# Access Compliance Report

## Public Rights-of-Way

### (Curb Ramps)

Intersection ID: 29962	Main Street: CANIPE_DR	Cross Street: WOODLAND_HILLS_RD	Location: W
ADA ID: 3FE14D983FF5	Ramp Type: Perp	Initial Pass/Fail: Fail	Overall Compliance: No
Severity Score: 8.75			
Codes/Mitigation Info/Possible Solution		Field Measurements/Component Compliance

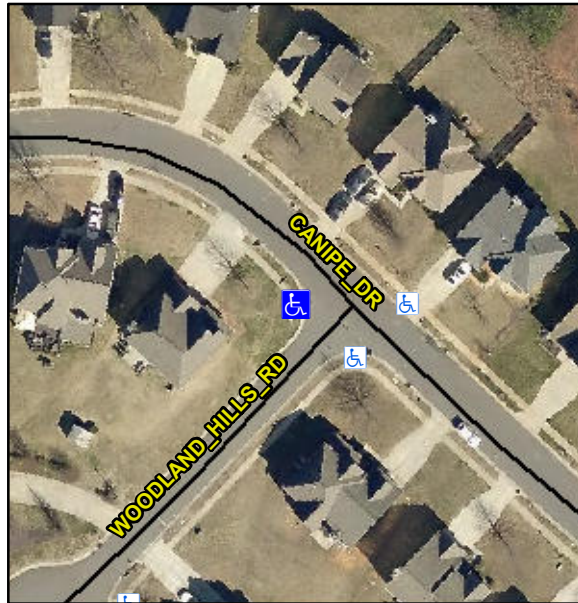
**R304.5.1**

Compliance	Description	Data	Compliance	Description	Data
N/A	Ramp Length (in)	48.0	Yes	Ramp Slope (%)	5.4
No	Ramp Width (in)	41.0	Yes	Ramp XSlope (%)	1.2
N/A	Flare Type LT	N/A	N/A	Flare Type RT	N/A
N/A	Flare Slope LT (%)	N/A	N/A	Flare Slope RT (%)	N/A
N/A	Flare Traversable LT?	N/A	N/A	Flare Traversable RT?	N/A
N/A	Landing Length (in)	N/A	N/A	DWS Provided?	N/A
N/A	Landing Width (in)	N/A	N/A	DWS Contrast?	N/A
N/A	Landing Slope (%)	N/A	N/A	DWS Length (in)	N/A
N/A	Landing X Slope (%)	N/A	N/A	DWS Full Width?	N/A
N/A	Landing Curb? (Y/N)	N/A	N/A	DWS Offset (in)	N/A
N/A	Shared Landing?	N/A			
N/A	Gutter Ponding?	N/A	N/A	Gutter Slope (%)	N/A
N/A	Gutter Lip Ht (in)	N/A	N/A	Gutter X Slope (%)	N/A
N/A	Painted X Walk1?	No	N/A	Painted X Walk2?	N/A
	X Walk 1 Direction	To SE		X Walk 2 Direction	N/A
N/A	X Walk 1 Width (in)	N/A	N/A	X Walk 2 Width (in)	N/A
	X Walk 1 Slope (%)	0.0		X Walk 2 Slope (%)	N/A
	X Walk 1 X Slope (%)	1.0		X Walk 2 X Slope (%)	N/A

**Remove & Replace Entire Ramp.**
